Groundwater Transfer Review Summary Form

Transfer/PA # T- 14837

Application: T-14837

Applicant Name: Roats Water System Inc.

Hydrograph 1. The applicant’s wells have water level elevations near 3400 ft amsl.

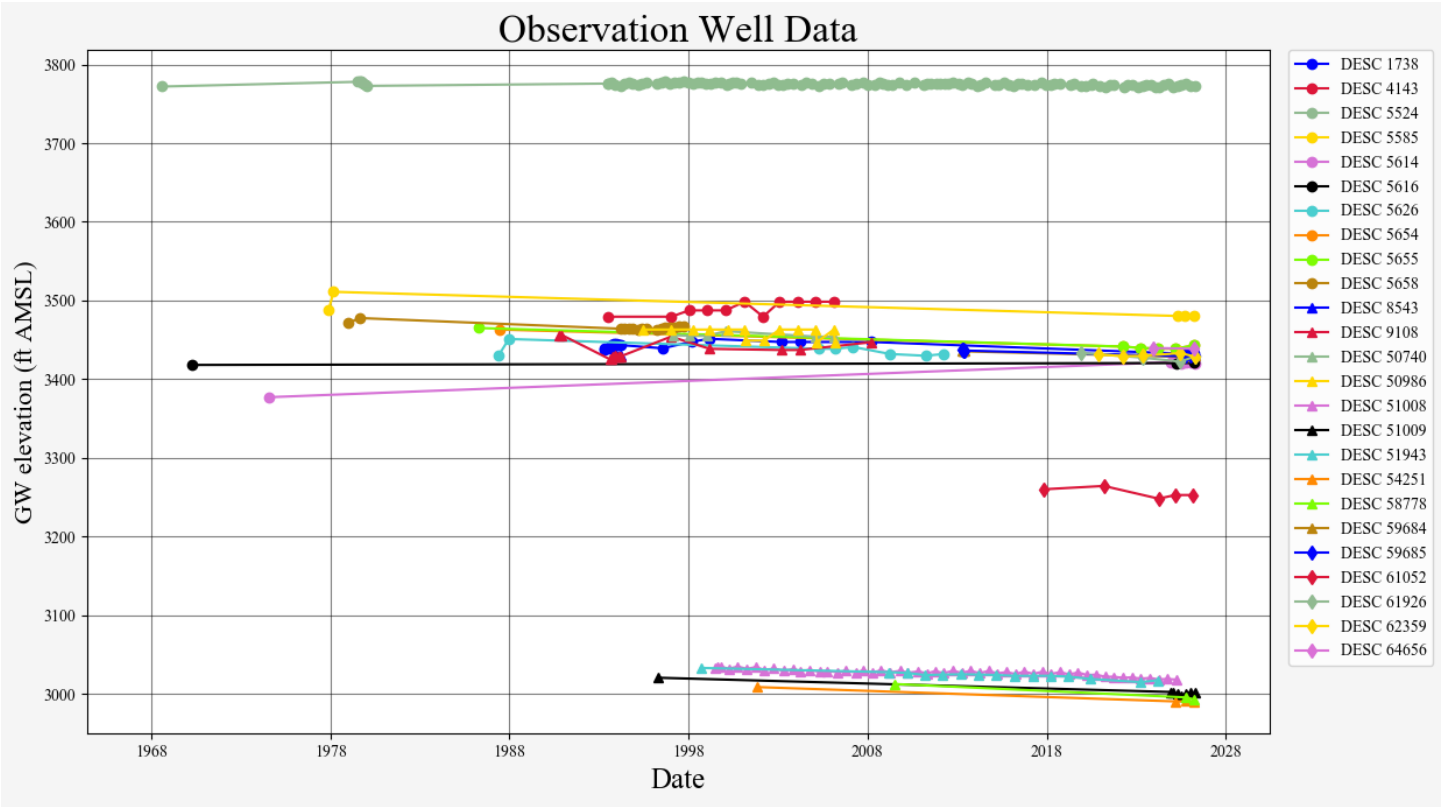
2. Will the proposed POA develop the same aquifer (source) as the existing authorized POA?
☒ Yes ☐ No Comments: The authorized and proposed wells access the Deschutes regional aquifer in the Bend area. Water level elevations in the FROM and TO wells are approximately 3440 feet AMSL.
